# Access Compliance Report

## Public Rights-of-Way

Intersection ID: 47569	Main Street: ROWE_CT	Cross Street: HERMSLEY_RD	Location:	E
ADA ID: EF4CB34C8106	Ramp Type: Perp	Initial Pass/Fail: Fail	Overall Compliance: No	Severity Score: 35
Codes/Mitigation Info/Possible Solution		Field Measurements/Component Compliance

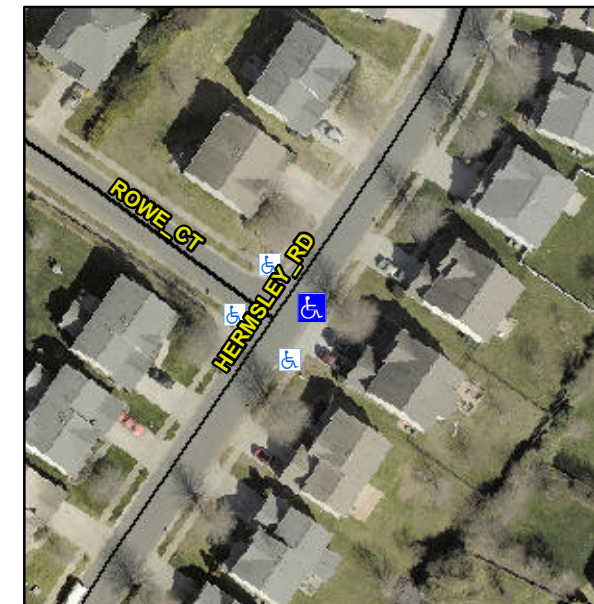
**Remove & Replace Entire Ramp.**

**R304.5.1, R304.2.2**

Compliance	Description	Data	Compliance	Description	Data
N/A	Ramp Length (in)	47.5	No	Ramp Slope (%)	12.1
No	Ramp Width (in)	47.5	Yes	Ramp XSlope (%)	2.1
N/A	Flare Type LT	N/A	N/A	Flare Type RT	N/A
N/A	Flare Slope LT (%)	N/A	N/A	Flare Slope RT (%)	N/A
N/A	Flare Traversable LT?	N/A	N/A	Flare Traversable RT?	N/A
N/A	Landing Length (in)	N/A	N/A	DWS Provided?	N/A
N/A	Landing Width (in)	N/A	N/A	DWS Contrast?	N/A
N/A	Landing Slope (%)	N/A	N/A	DWS Length (in)	N/A
N/A	Landing X Slope (%)	N/A	N/A	DWS Full Width?	N/A
N/A	Landing Curb? (Y/N)	N/A	N/A	DWS Offset (in)	N/A
N/A	Shared Landing?	N/A			
N/A	Gutter Ponding?	N/A	N/A	Gutter Slope (%)	N/A
N/A	Gutter Lip Ht (in)	N/A	N/A	Gutter X Slope (%)	N/A
N/A	Painted X Walk1?	No	N/A	Painted X Walk2?	N/A
	X Walk 1 Direction	To NW		X Walk 2 Direction	N/A
N/A	X Walk 1 Width (in)	N/A	N/A	X Walk 2 Width (in)	N/A
	X Walk 1 Slope (%)	1.2		X Walk 2 Slope (%)	N/A
	X Walk 1 X Slope (%)	3.3		X Walk 2 X Slope (%)	N/A
